FINAL DRAINAGE REPORT

FALCON MEADOWS AT BENT GRASS FILING NO. 1

Engineering Review

Galloway responses

DP 16 - At Grade Inlet

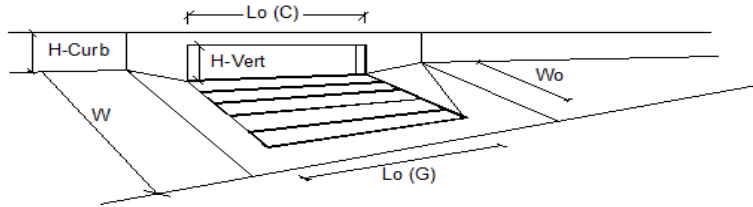
WARNING: MAJOR STORM max. allowable capacity is less than the design flow given on sheet 'Inlet Management'

Update with PDR sheets

Updated with revised flow
in routing spreadsheet
